Title: Calidus Rotor Head II to III Upgrade		
AG-SB-2023-03-C-EN	Effective Date: 15.10.2023	Compliance Category: A - MANDATORY B - RECOMMENDED C - OPTIONAL
Applicability		
Aircraft type & model: AutoGyro Calidus	Affected Serial number(s): Calidus fitted with Rotor Head II	
The maintenance manual to be referenced is this stated or subsequent issue.		As per AutoGyro website
This form is the response from AutoGyro GmbH either against a problem found in the product in service requiring a containment or rectification action, or as service information for aircraft modification incorporation. For help, contact airworthiness@auto-gyro.com .

Reason and overview of the Service Bulletin (cause of problem if known)

The AutoGyro Calidus has been produced with rotor head III as standard since April 2018. AutoGyro has developed a rotor head II to III modification set (46040) and are now able to offer this as an upgrade option to customers of Calidus with rotor head II.

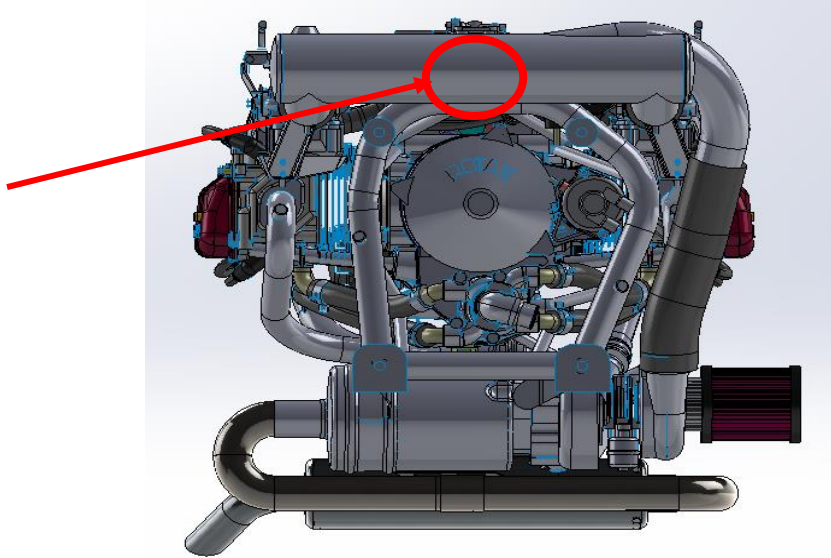
- 2.) Remove forward and after mast and all engine cover as described in job card 52-00-00 4-1 (Removal-Installation: Cowlings).
- 3.) Replace the coupling with a coupling IV.1 according to job card 63-11-10 4-1. Be aware that the airbox in the Rotax 914 has to be modified for the coupling to fit in.

Remove the airbox and carefully create a 5-10mm deep indentation of around 30mm diameter into the airbox to create a gap between airbox and vertical pre rotator coupling shaft. Refit the airbox.

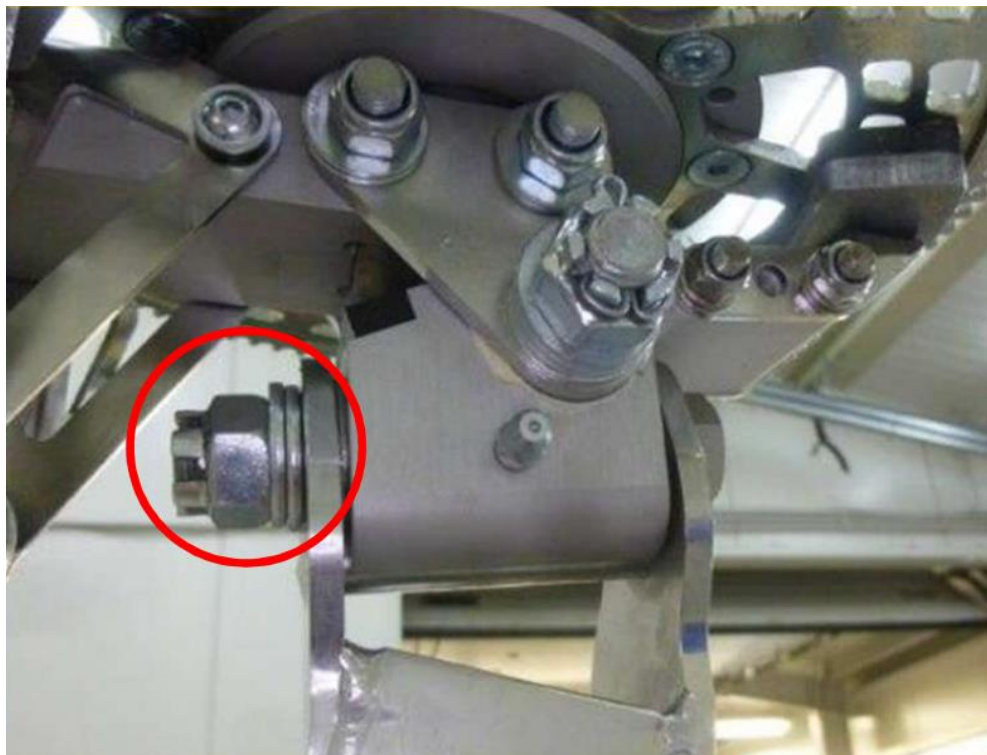
Insert 2x disc springs (convex side outwards) + shim into the front and rear rotor head as shown.

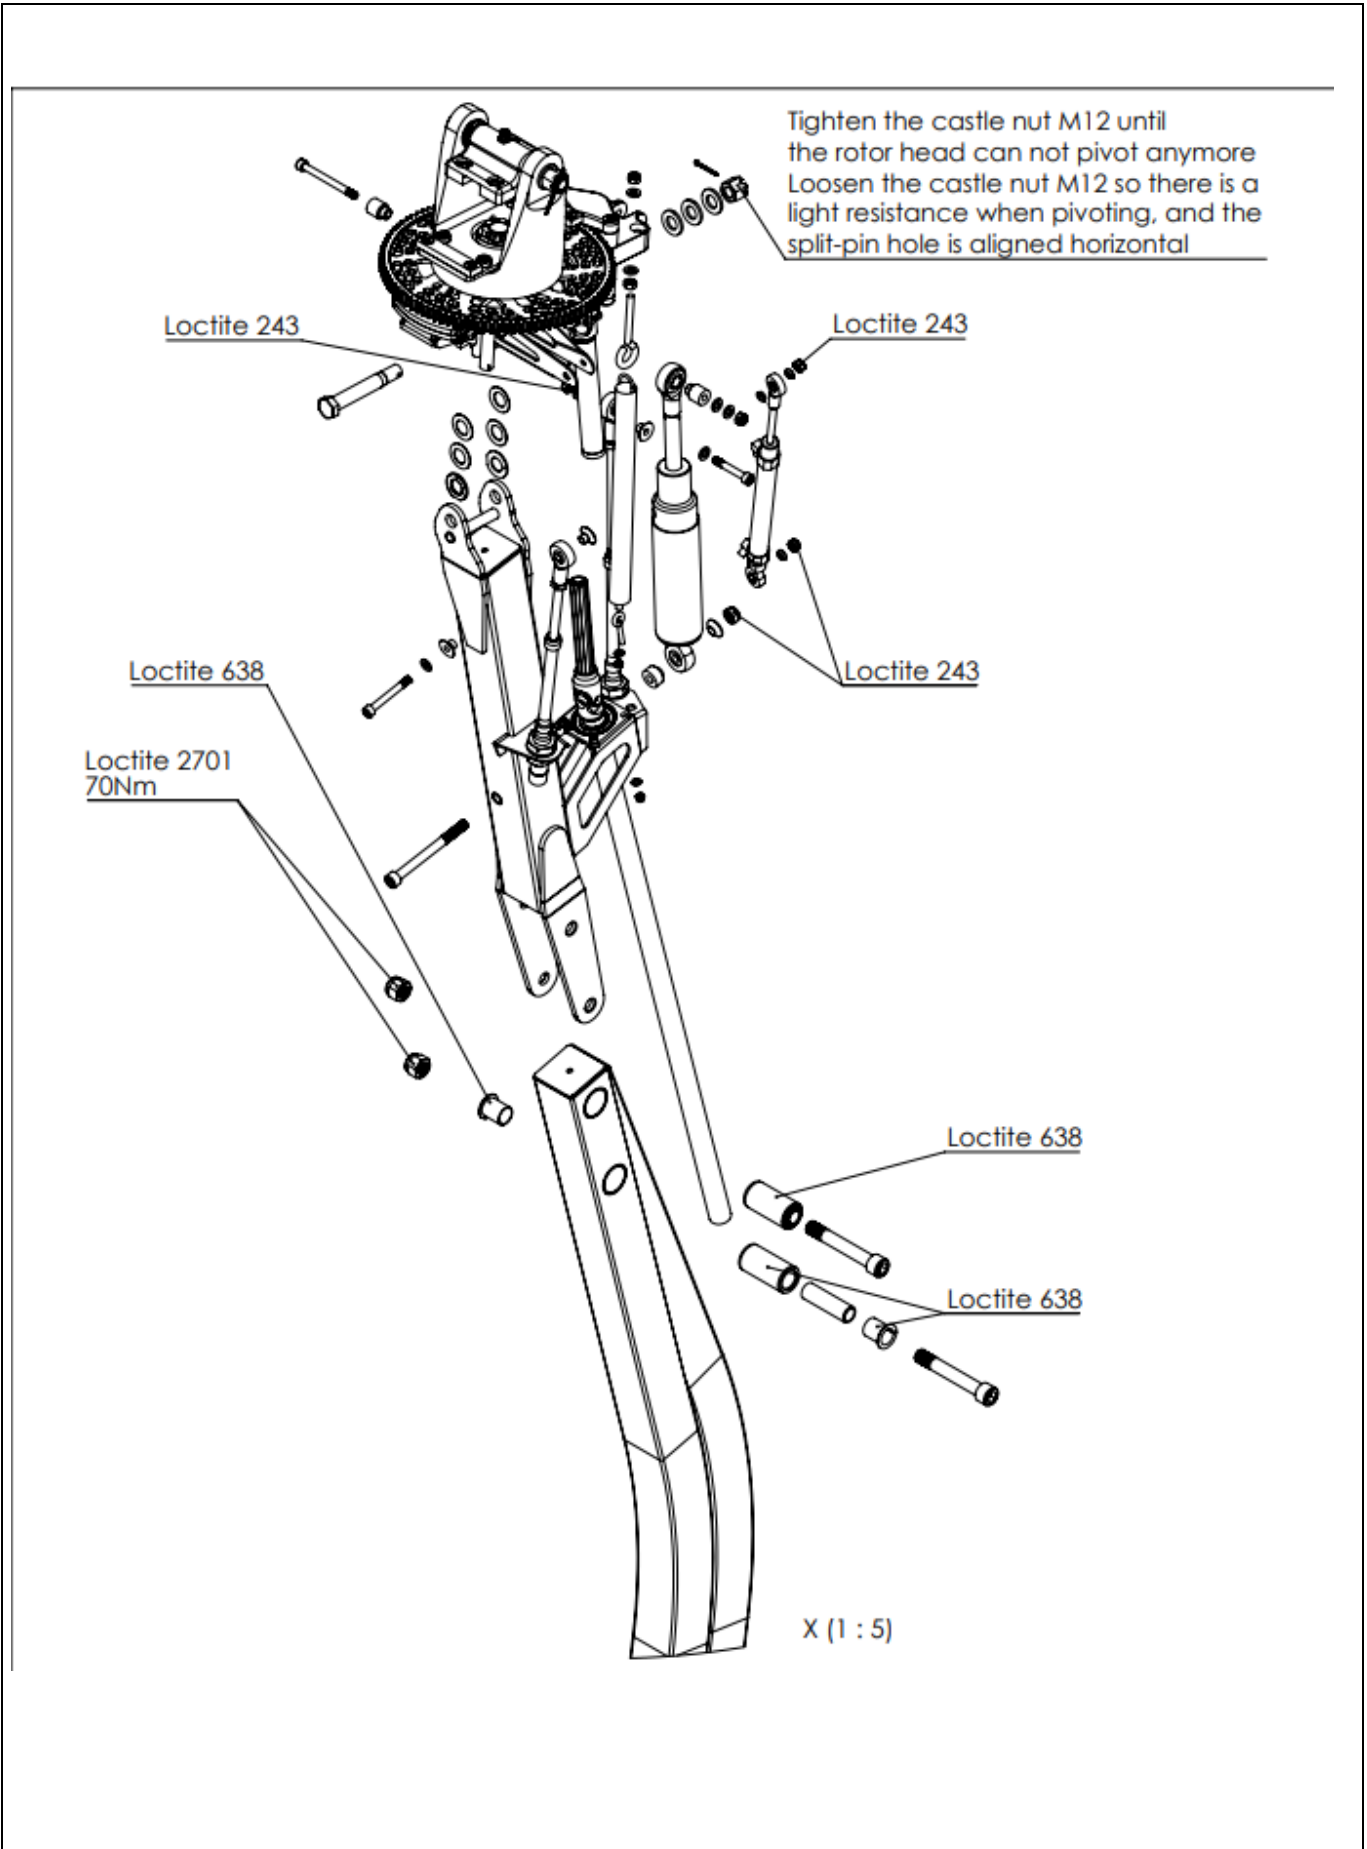
Assemble the rotor head to the mast making sure that all washers are in place and secure using the gimbal bolt + U13. Fit the castle nut M12 and 2x washer U13 as shown.

Caution: The forward U13 under the bolt head must not lie on the welding seam!

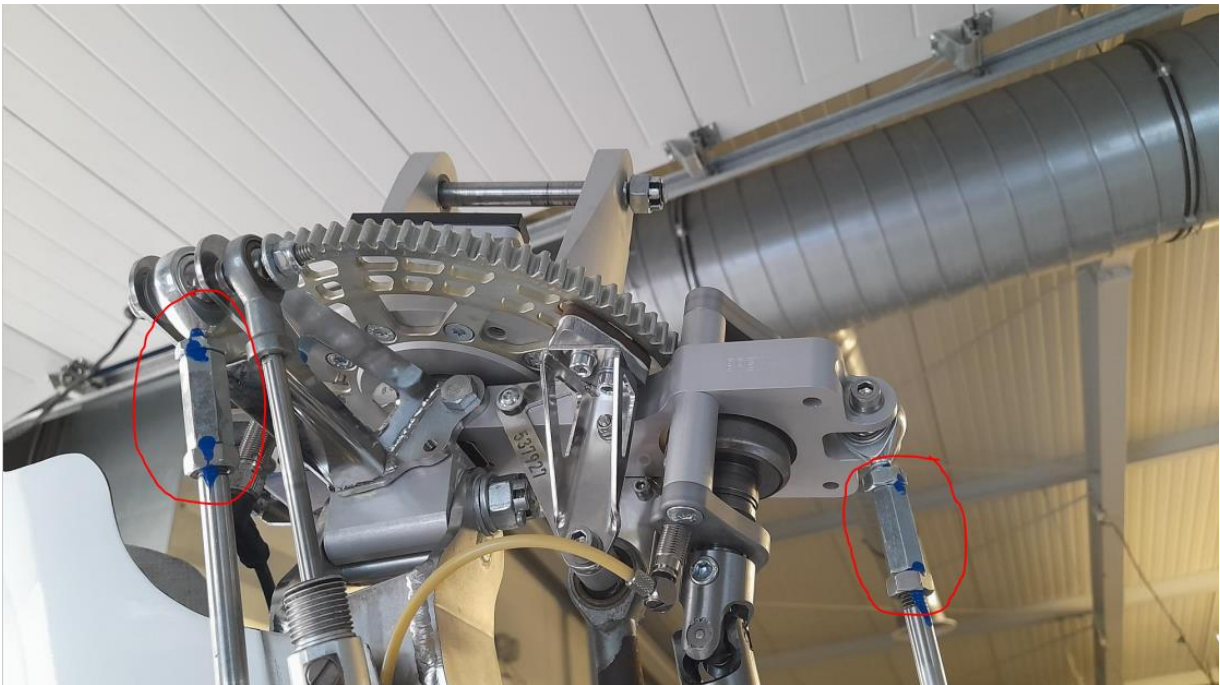
It may be necessary to extend the control push pull cables for the rotor head III upgrade. Extension pieces are provided, 30mm for roll and 40 mm for pitch PPC. A new ball end is included in the set. After finishing the installation of rotor head III and checking/adjusting the steering angles the extension pieces must be secured with mechanic lacquer.

Ensure a minimum of 6 threads engagement within the extension piece, with a locknut either end.

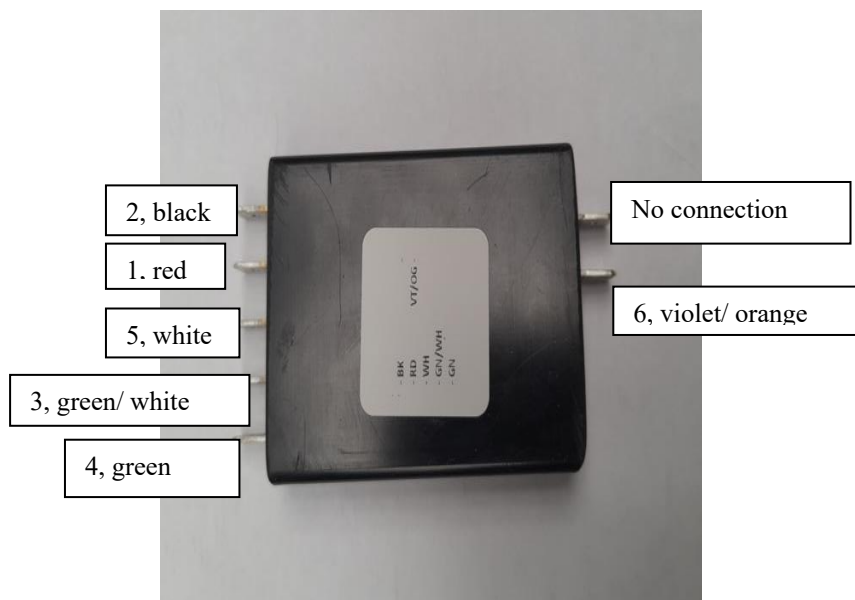
- 14.) If everything is inspected check the fitting of the cowling. Due to the rotor head upgrade it needs to be reworked.

Mark the edge of the part and carefully grind a little bit away until the cowling can be installed without touching any moving part.

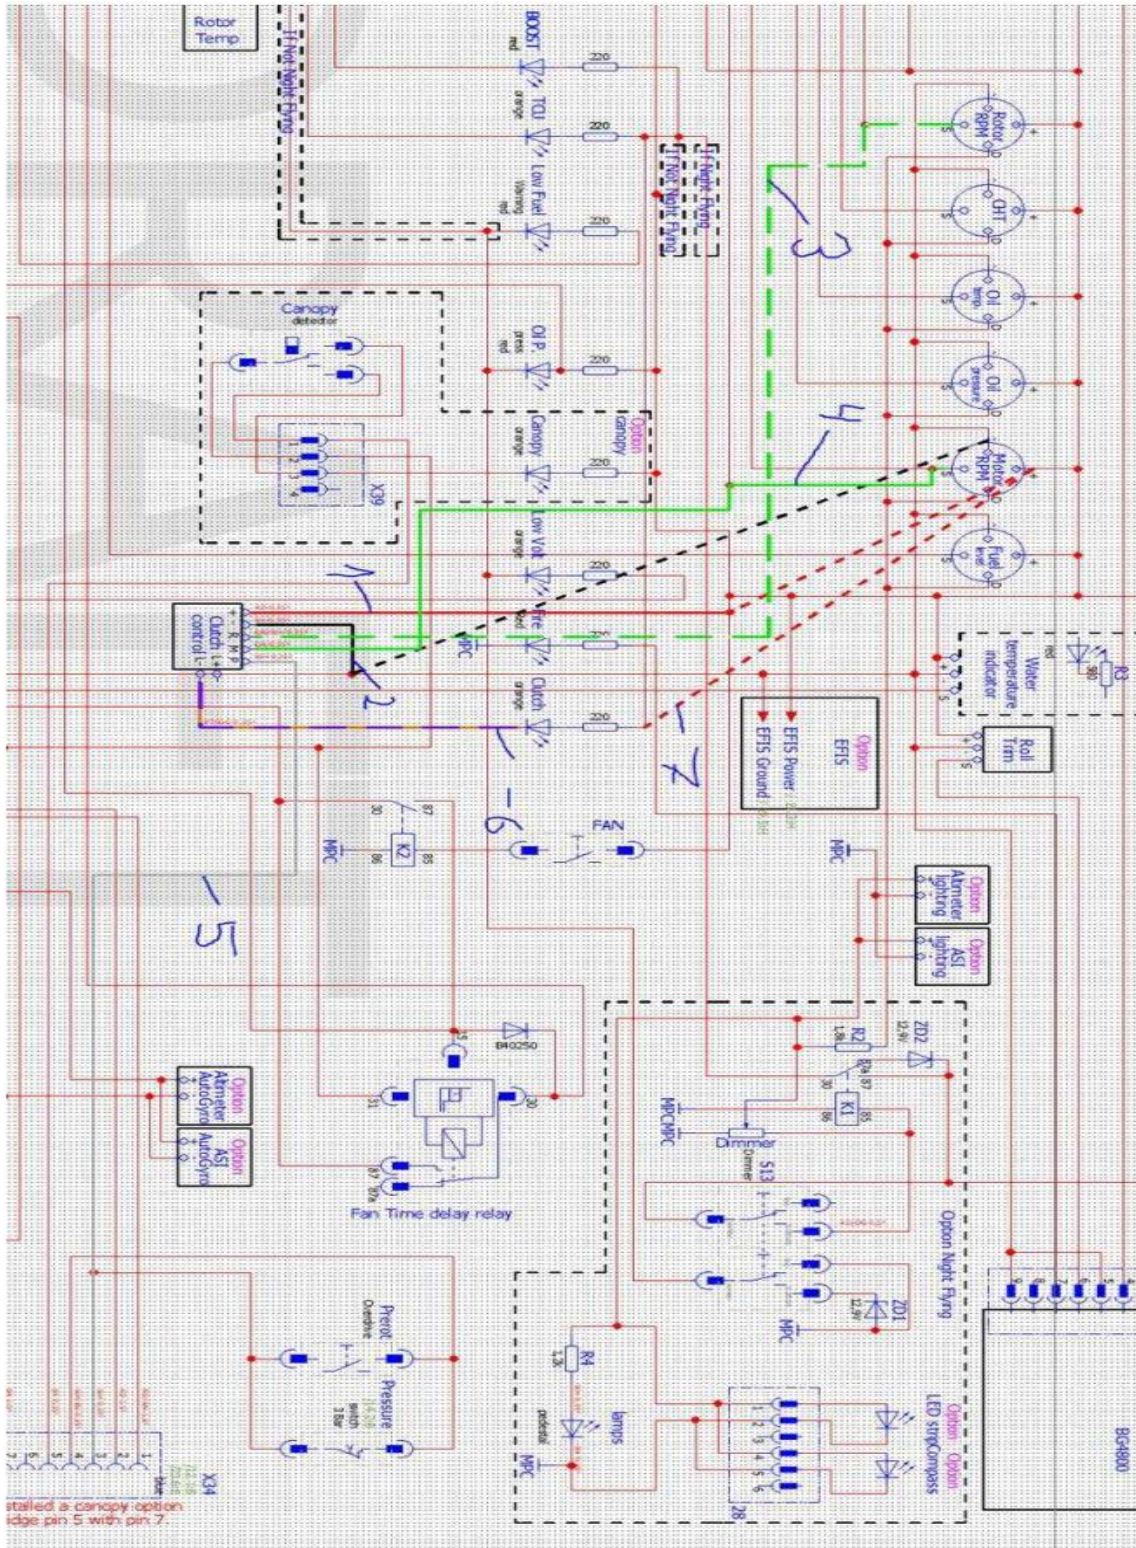
Cable colour positions are described on the rear of the clutch control board. Numbers in the photo below relate to the numbers in the circuit diagram above.

Connections 1 to 4 and 7 can be connected directly to the respective instrument (rotor rpm/engine rpm) connections. Connection 5 is pinned in position 3 of the 9-pole plug from the cockpit side of the stick harness. The opposite ends of cables 1 to 6 must be connected to the clutch control board in the positions shown, and 7 to the LED, along with the plus cable from the instrument.
